4687 Verona Road Contract 9351 MUNIS 14850

Developer: McDonald's Corporation

Summary of Improvements:

SHEET NO C200

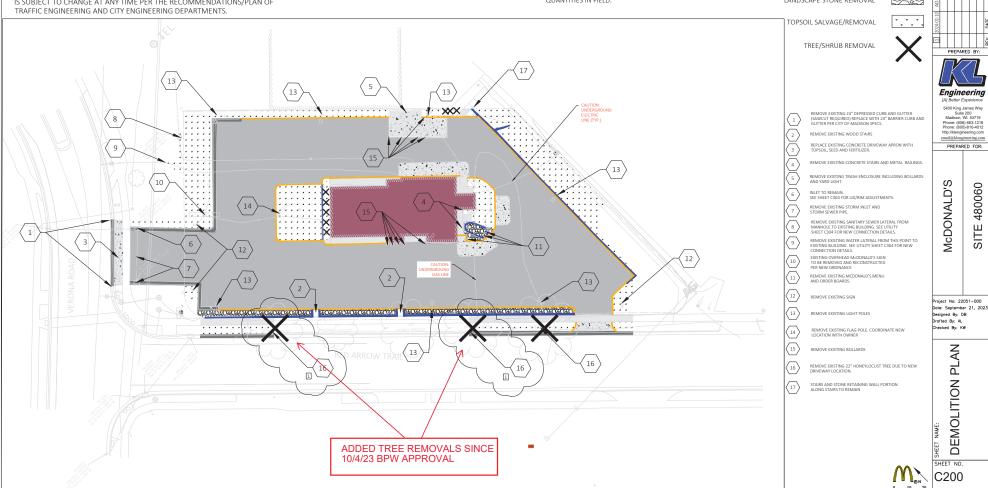
- Repair or replace existing sidewalk, terrace, curb & gutter as needed
- Protect existing public street terrace trees on Red Arrow Trail. Tree removals as approved by City Forestry
 (Change since 10/4/23 BPW approval two additional street tree removals added following City Forestry
 review of submitted Existing Tree Inventory Report by Developer total of three tree removals).
 New street terrace trees as required by City Forestry.
